**DeKalb County Department of Planning & Sustainability**

**STAFF ANALYSIS**

**Case No.:** CZ-22-1245934 **Agenda #:** D6

**Request:** To modify zoning conditions to remove condition #1 pursuant to CZ-06-1241 restricting the use of the property to office and retail uses to allow a drive-through car wash in the C-1 (Local Commercial) zoning district.

PROJECT NO.:	PROJ. MGR.:
DATE:	DRWN. BY:
SCALE:	CHKD. BY:
DRAWING SERIES:	
SITE	
SHEET NO.	C-2.0

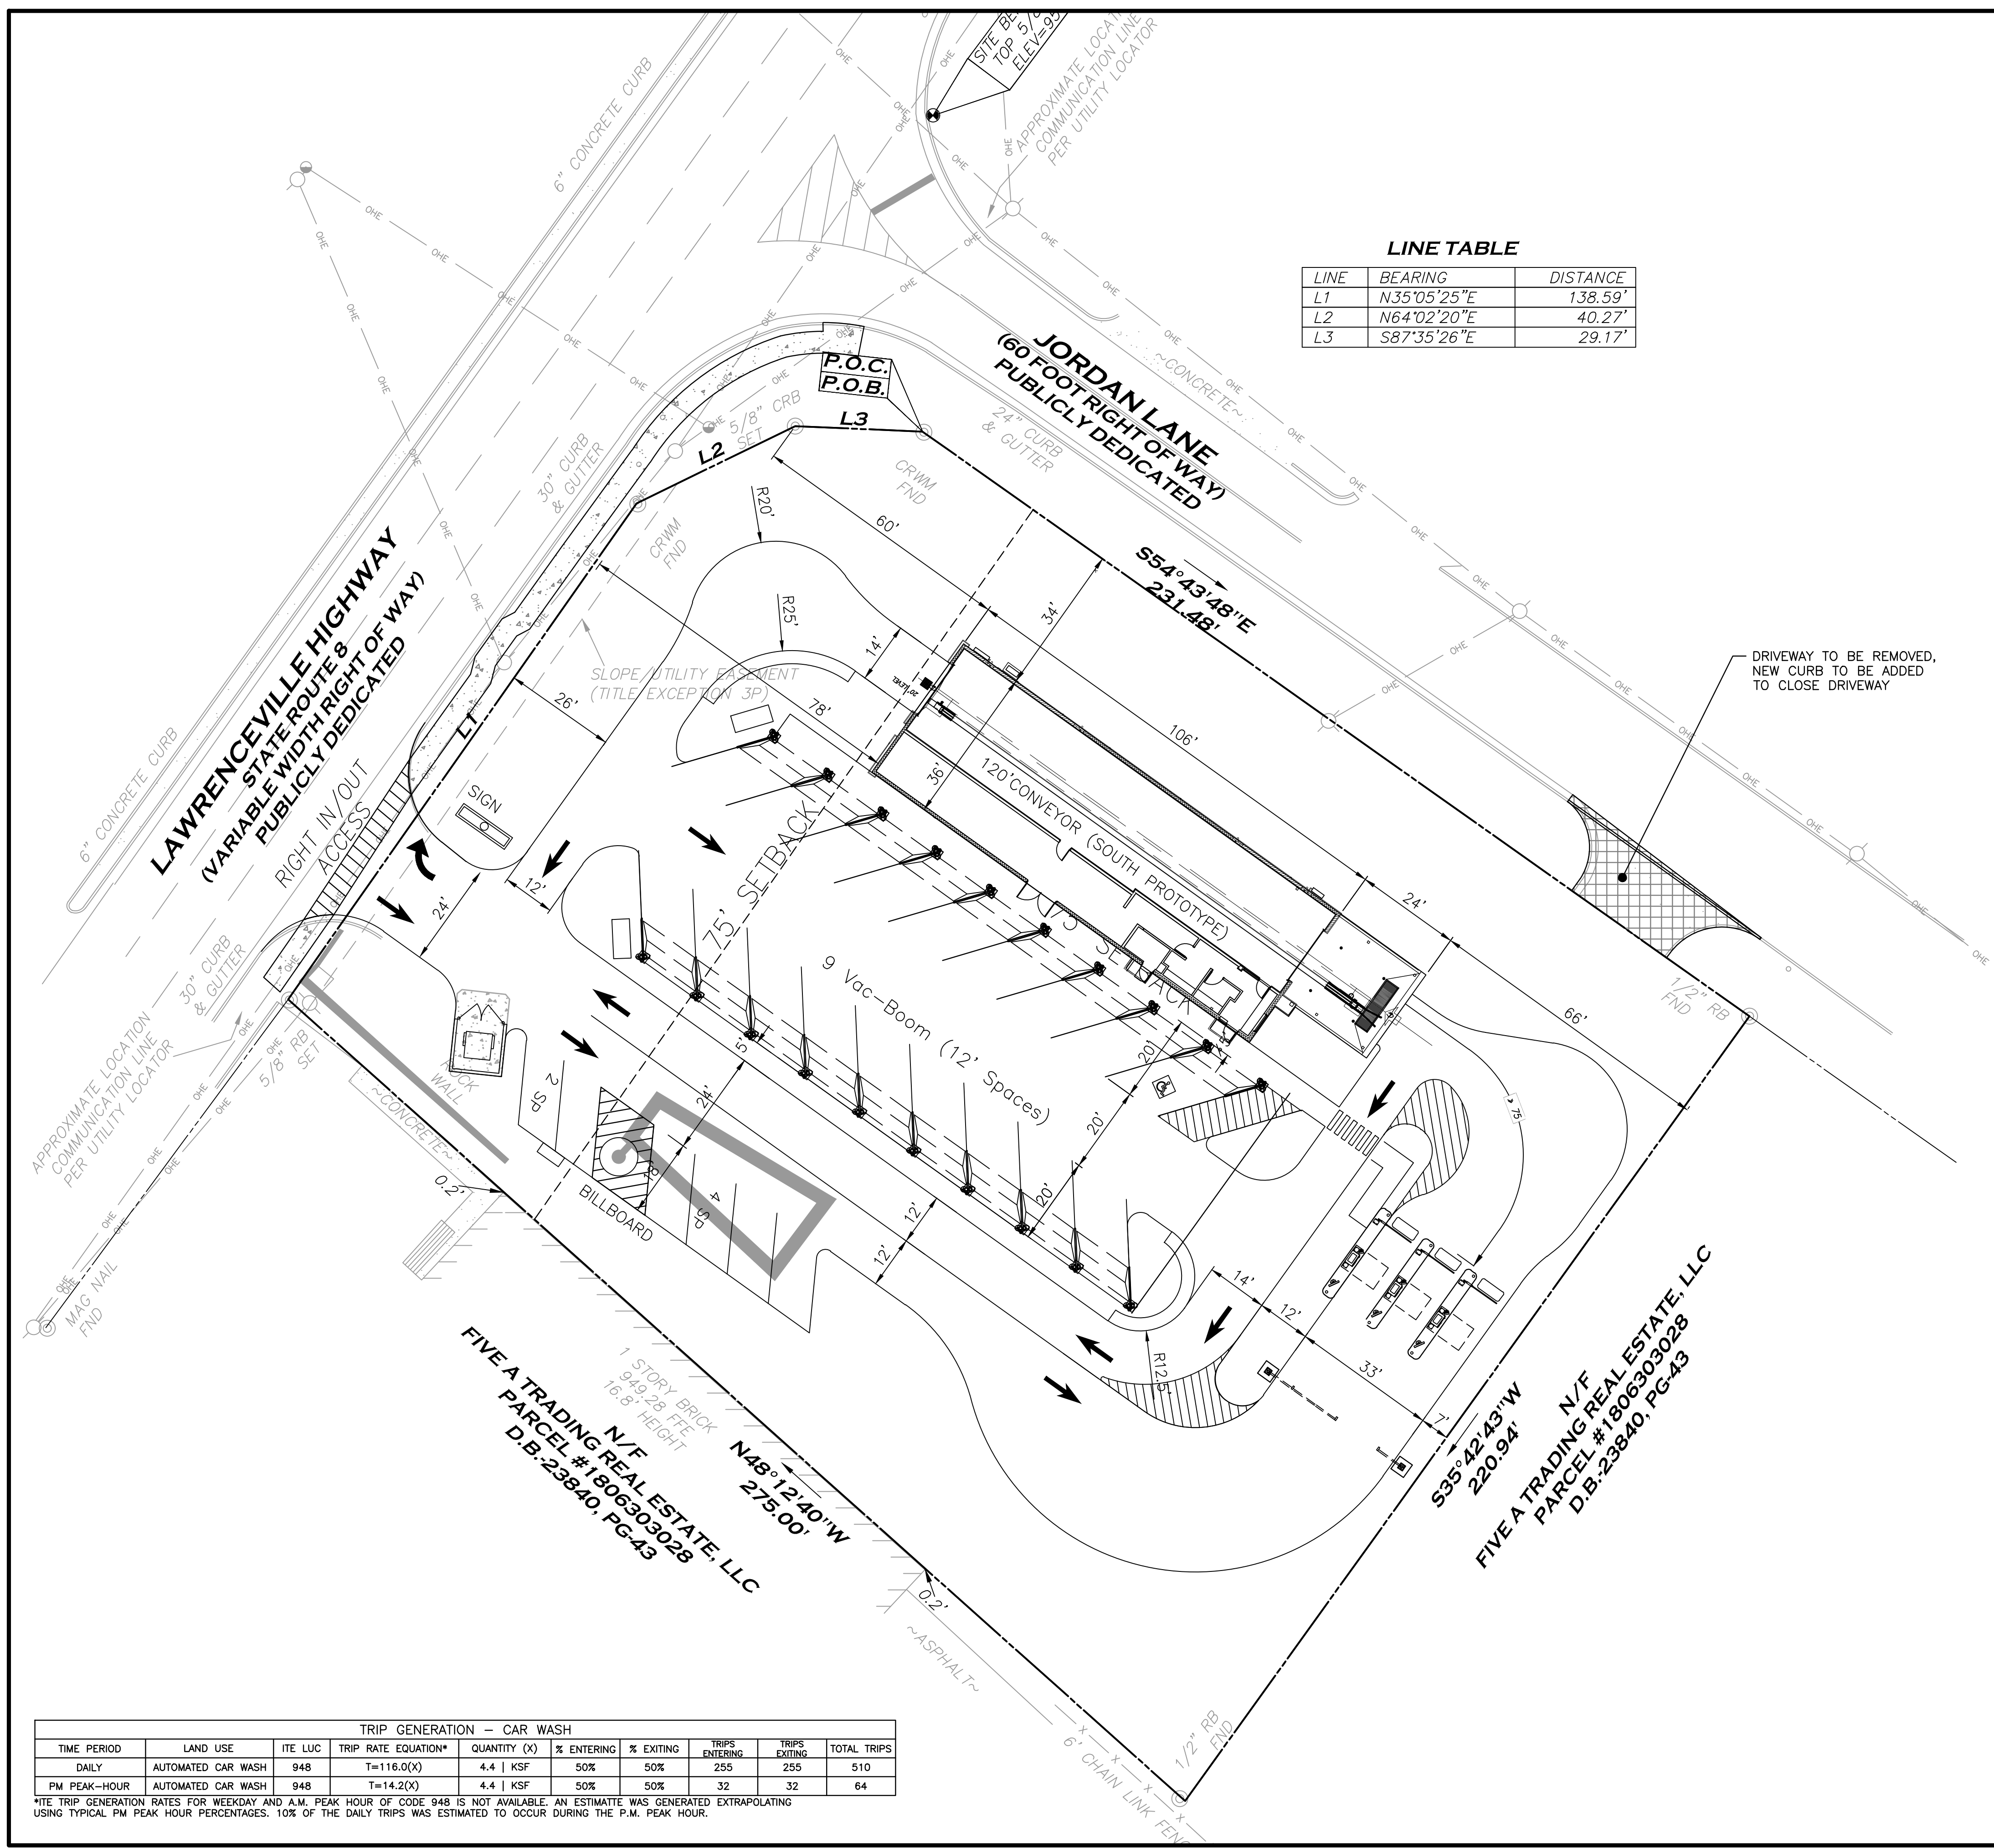
Conceptual plan doesn't indicate the location of the stormwater management facility. Location of stormwater management shall be shown or compliance with the County stormwater management regulations shall be explained.

Runoff Reduction Volume shall be provided, unless technical justification is provided in regard to the unfeasibility. Strongly recommend investigating the site and identify location where RRv can be provided and re-design/revise the layout to comply with the RRv requirement.
